Request for Further Information (RFI) Response – 14-16 Marshall Avenue, St Leonards (DA56/2023)

Request for Further Information (RFI) Response – 14-16 Marshall Avenue, St Leonards (DA56/2023)

Response to RFI – 14–16 Marsahll St Leonards DA56/2023

Figure 1 Overshadowing Diagram – 12pm 21 June

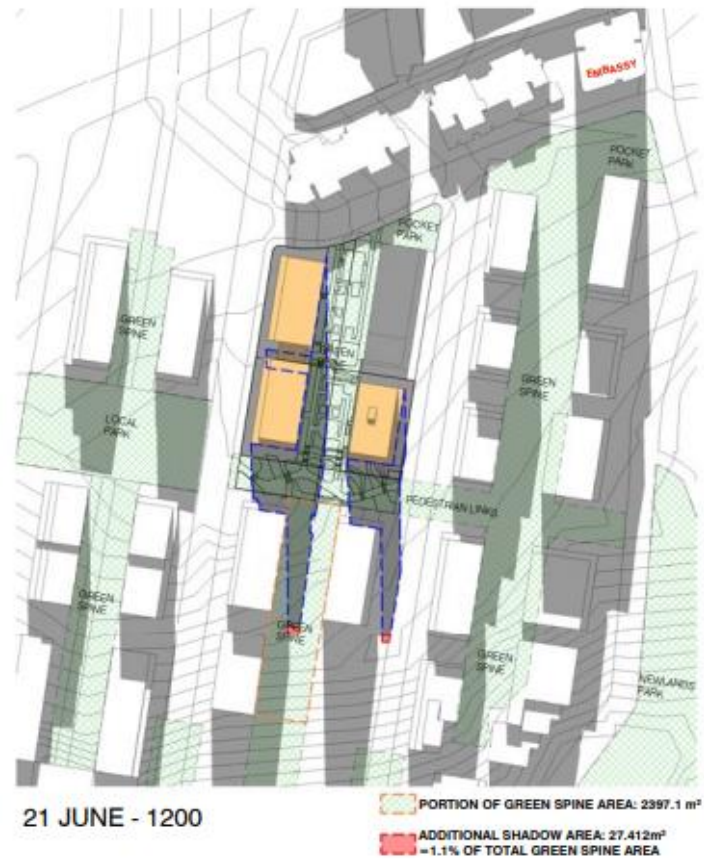
overshadowing of public and private open spaces (Green spines, parks) is to be minimised.

Council Comment	Proponent Response
Setbacks to the Link	
<i>The proposed development includes a non-compliance with the setback control to the east to west pedestrian link. The proposal includes a reduced upper level setback from 9m to 6m (above 5th storey) for Areas 14 and 15, which is a reduction of 3m.</i> <i>Insufficient justification has been provided to warrant supporting the proposed non-compliance. It is unclear what impacts would be generated from the non-compliant portion of the development. It is perceived that there would be an unacceptable impact on the public domain areas resulting from the reduced setback. Further justification is to be provided to enable a full assessment of the non-compliance including the following:</i> <i>Hourly shadow diagrams which clearly depict the isolated impacts from the non-compliant portion of the proposed development, in particular the green spine areas. The DCP requires that</i>	An RFI Response Report has been prepared by PTW to address the matters relating to architectural design that have been raised by Council. This report includes a detailed analysis of the impact of the proposed upper-level setback non-compliance on public domain areas to justify that the non-compliance will have a minimal impact on the amenity of surrounding areas. The report contains hourly shadow diagrams which demonstrate that the additional overshadowing associated with the non-compliant portion of the proposed development is minor to negligible. Additional overshadowing is only cast between 10am – 1pm on 21 June and, of this, there is only additional overshadowing cast on the green spine between 11am-12pm. This additional overshadowing is very minor and is limited to a maximum of only 1.1% of the total green spine area, as shown in the diagram below. Therefore, the proposed setback non-compliance will not result in any significant or adverse overshadowing impacts to green spine, as the additional shadow cast is minimal. The area of non-compliance will not create additional shadow to Newlands Park beyond existing shadow casted by exiting and approved development. The overshadowing of public and private open spaces is minimised despite the non-compliance. Refer to the Design RFI Response Report for further detail and the full set of shadow diagrams.
